Keystone RV Company

SAFETY ADVISORY # 19-357

Hampton – Sunset Breakaway Wiring

ELECTRICAL WIRING - BARGMAN CORD

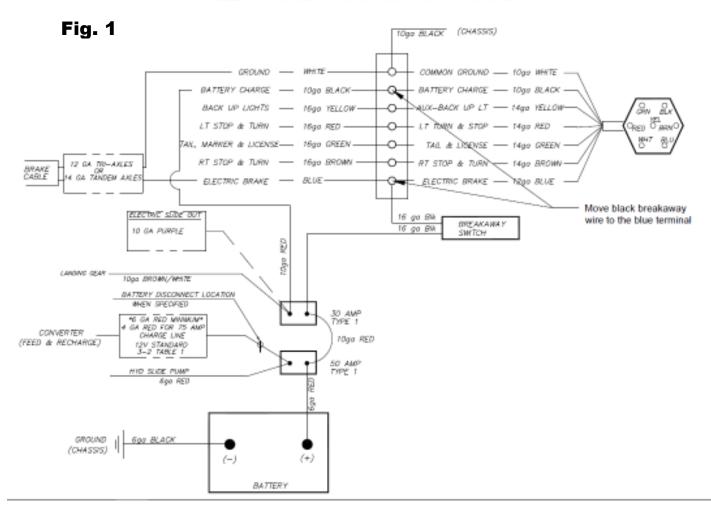
Remove the cover to the Bargman 7-way distribution box and inspect the installation of the breakaway wire. See Figures 1 & 2.

If the breakaway wire is connected to the black charge line, remove it and install it on the blue brake wire.

The remedy is to inspect the installation of the breakaway wiring at the Bargman 7-way box mounted on the drawbar frame. If needed, move ring terminal from the charge line to the blue brake wire terminal.
